**Re: Route 66 Plaza
8521 Central Ave NE
30-Day Temporary Certificate of Occupancy- Traffic Certification Only
Transportation Development Final Inspection**
Engineer's/Architect's Stamp dated 5-17-16 (K19D043)
Certification dated 2-5-19

ROUTE 66 PLAZA - LIVE/WORK DEVELOPMENT
SITE PLAN & PROJECT INFORMATION
8521 CENTRAL AVE. ALBUQUERQUE, NM
PROJECT #1611

TRAFFIC CERTIFICATION

SITE PLAN
SCALE: 1"=10'-0"

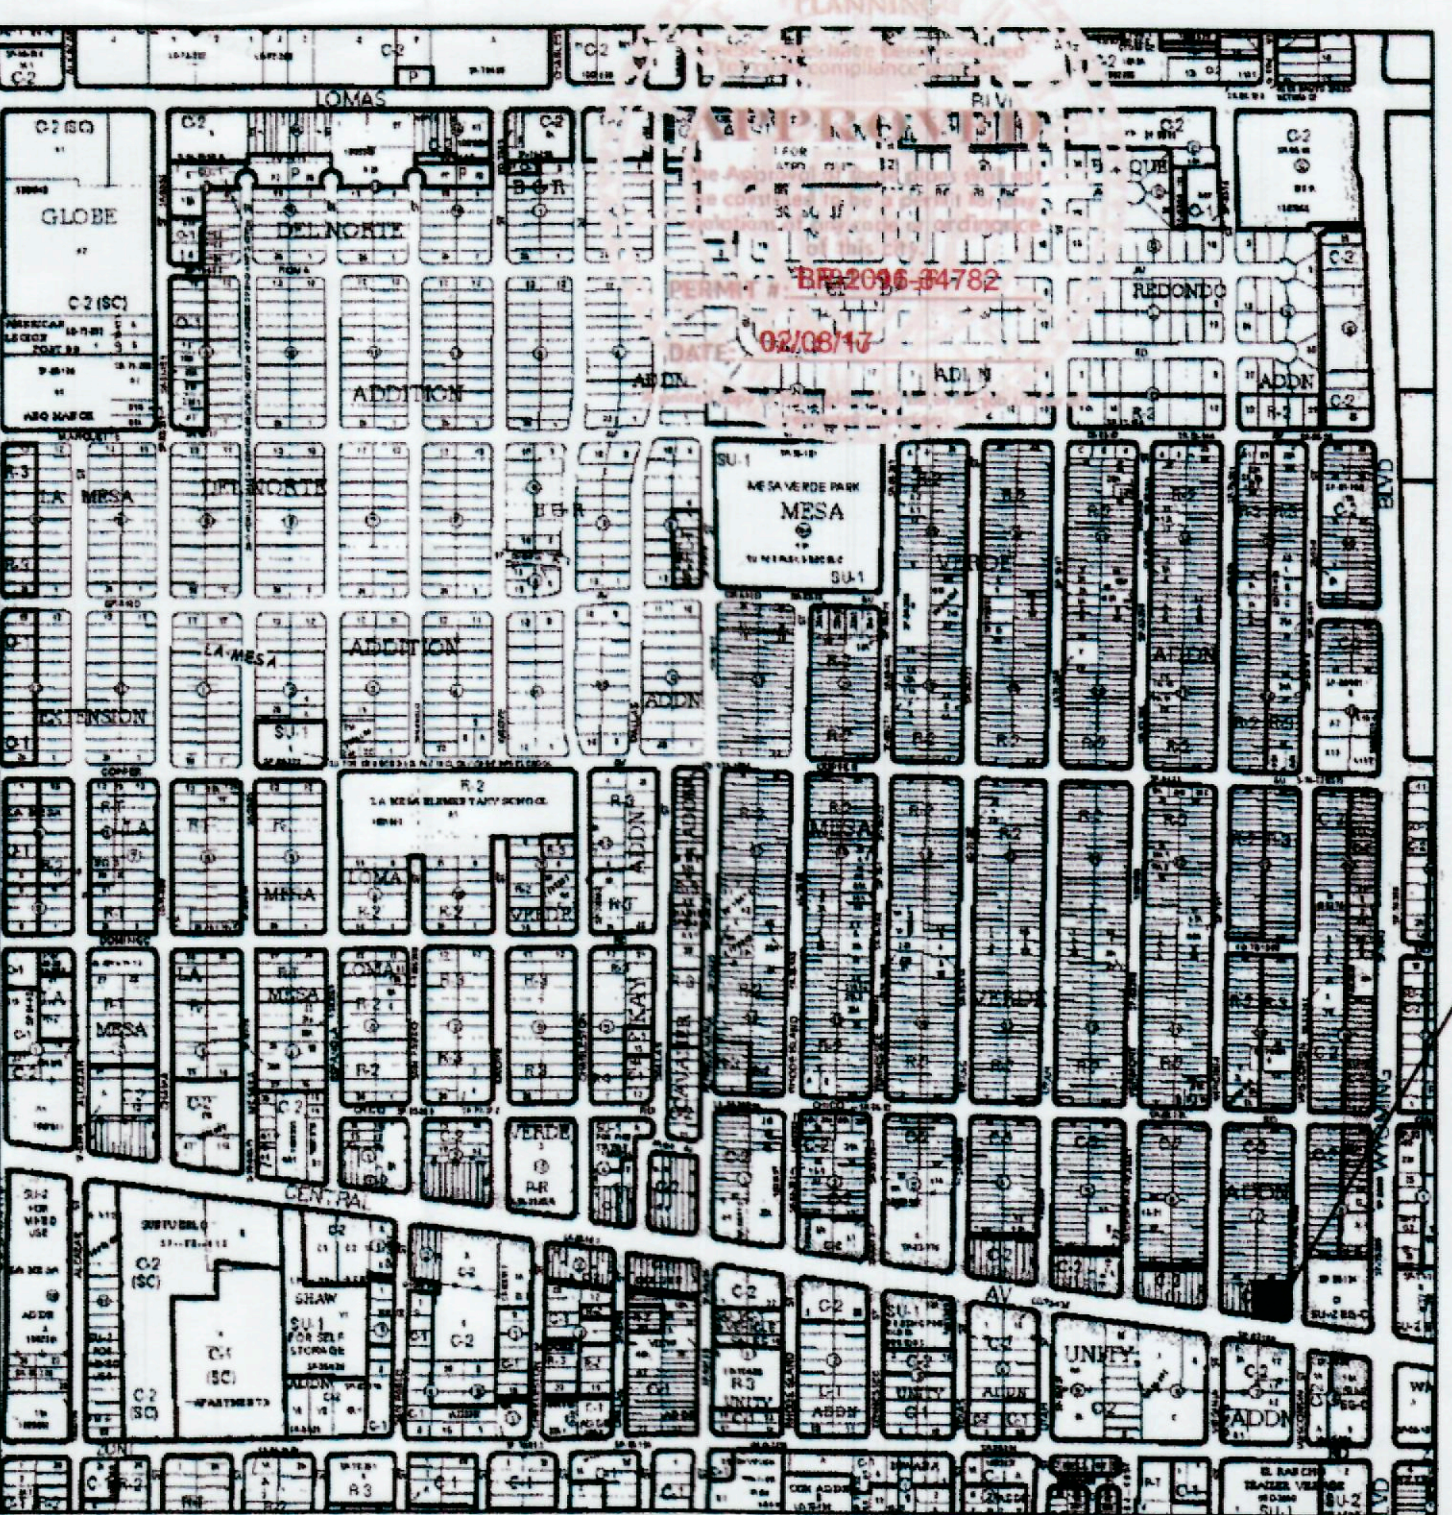
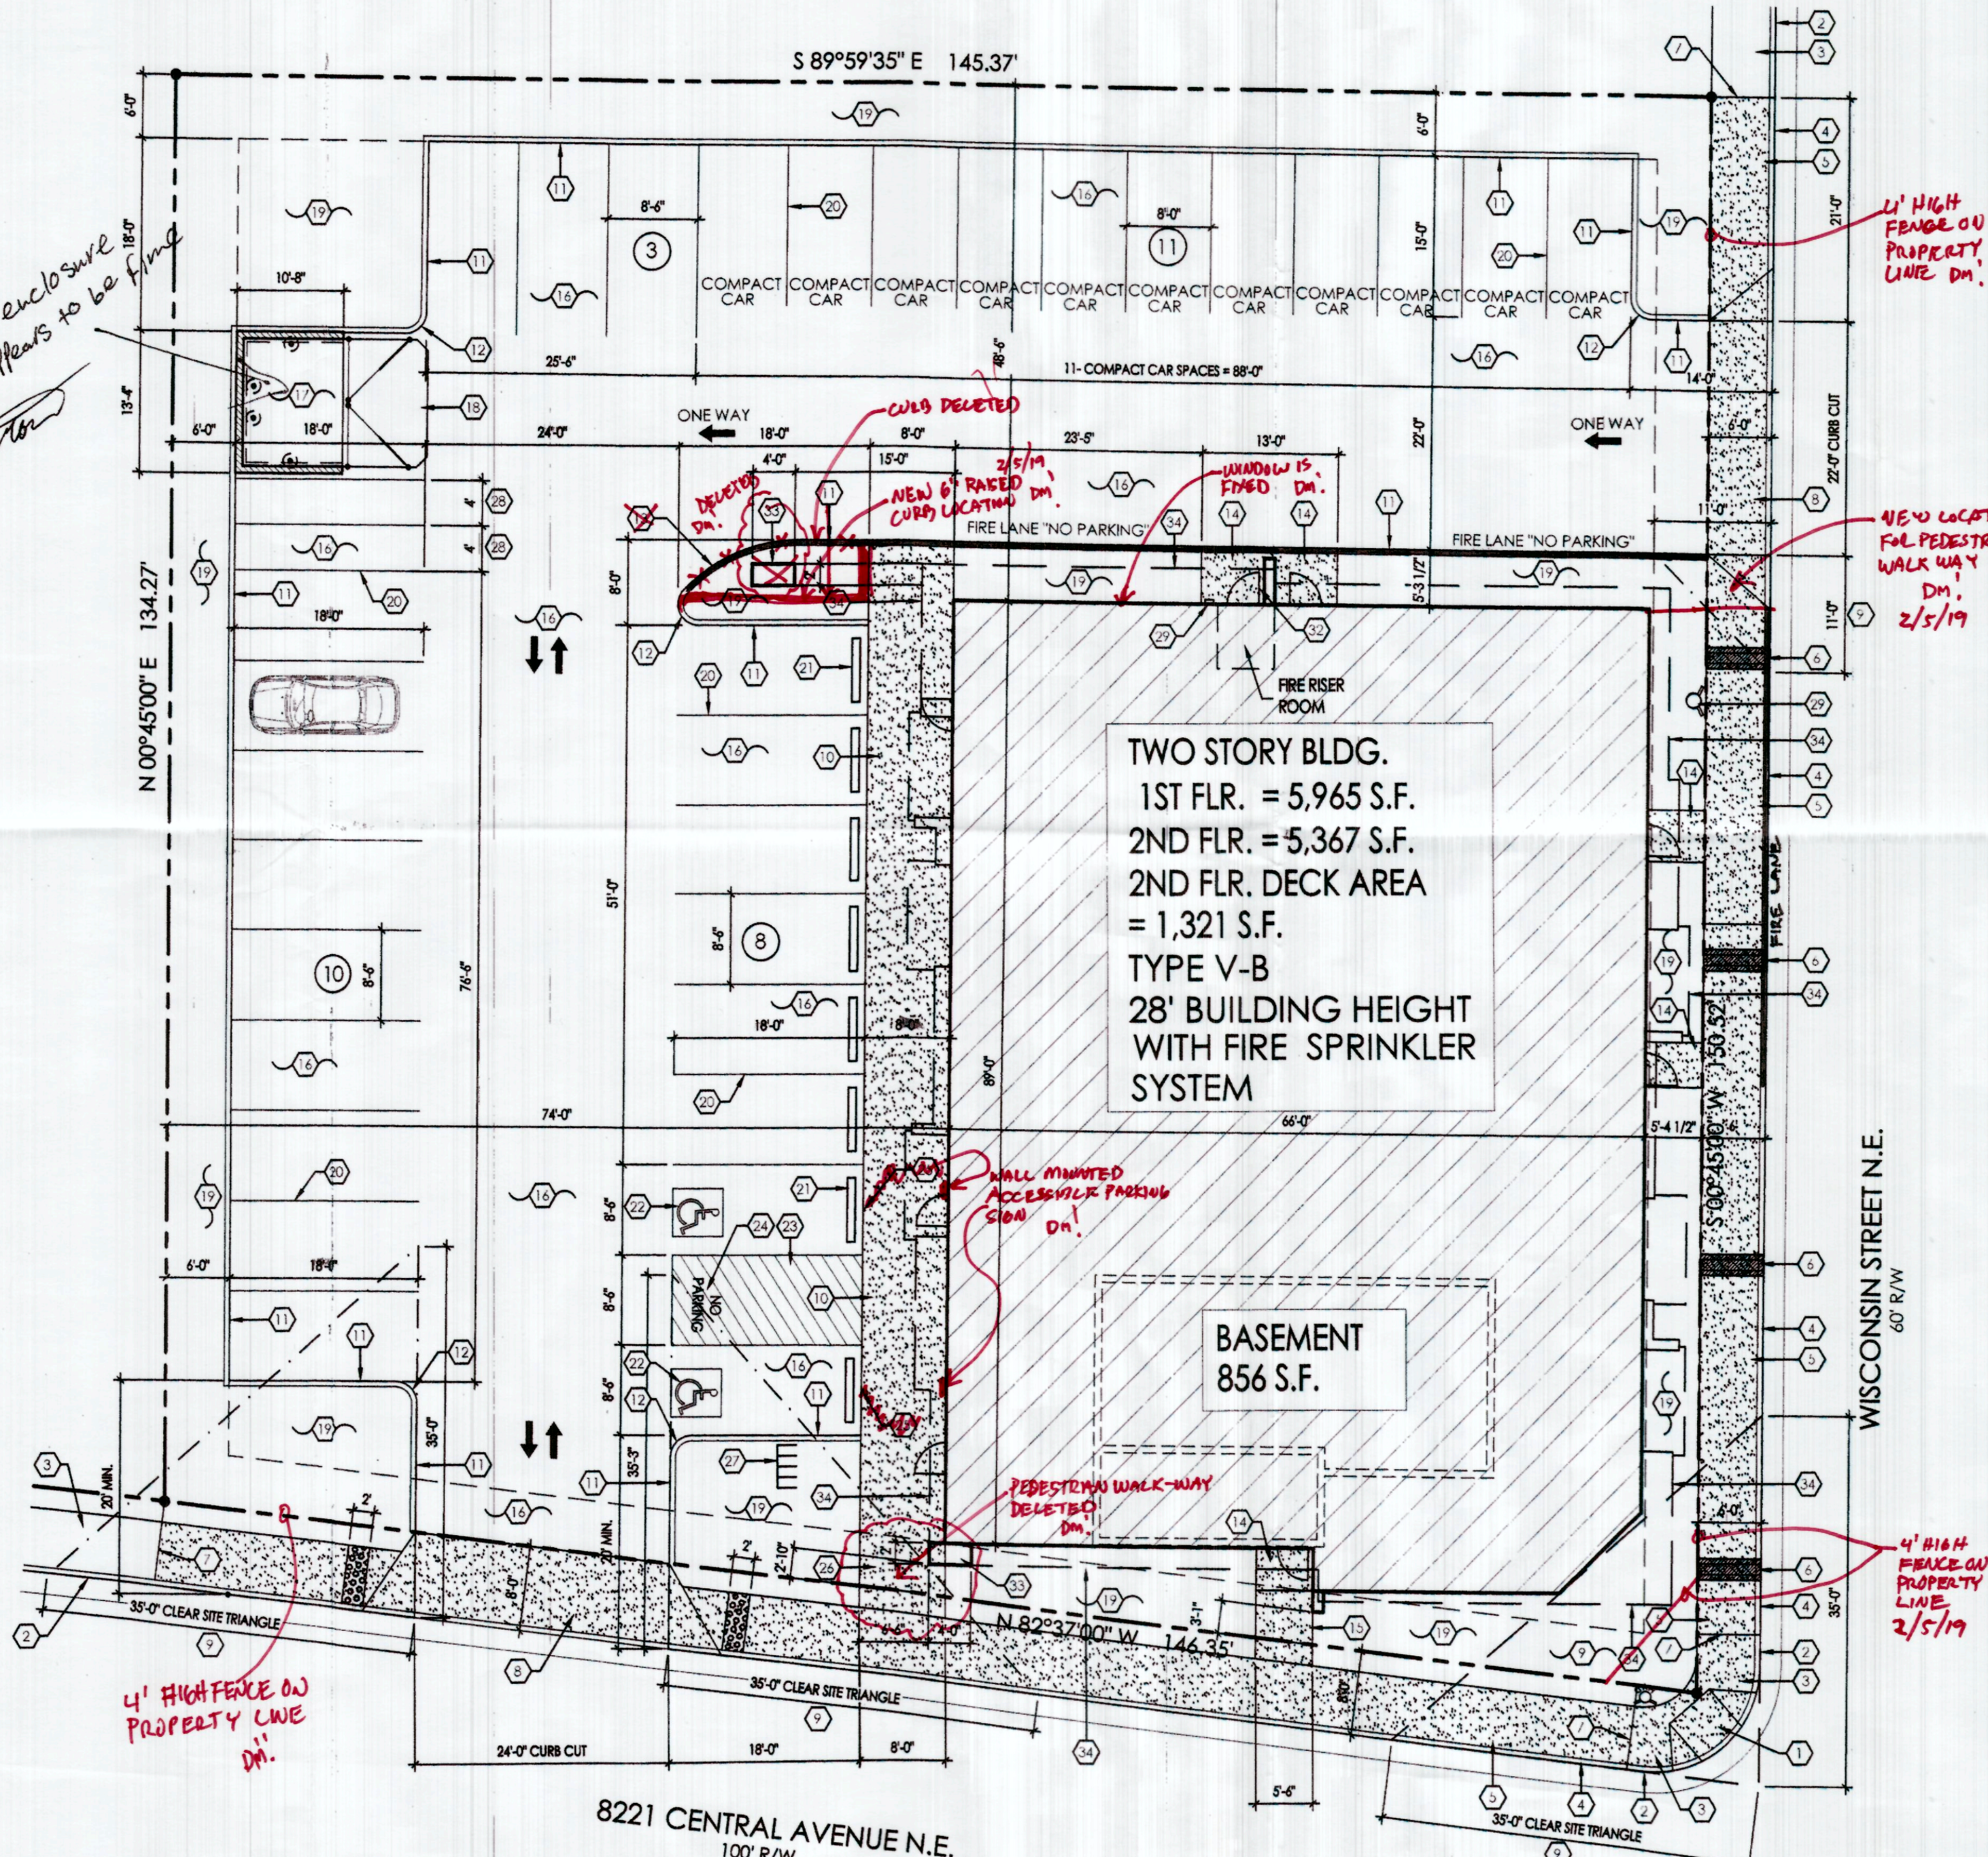
1. Please add bike rack per approved plan.
2. Please add wheel stops to the two ADA spaces.
3. Please send photos of corrections to PLNDRS@cabq.gov when requesting Final CO.
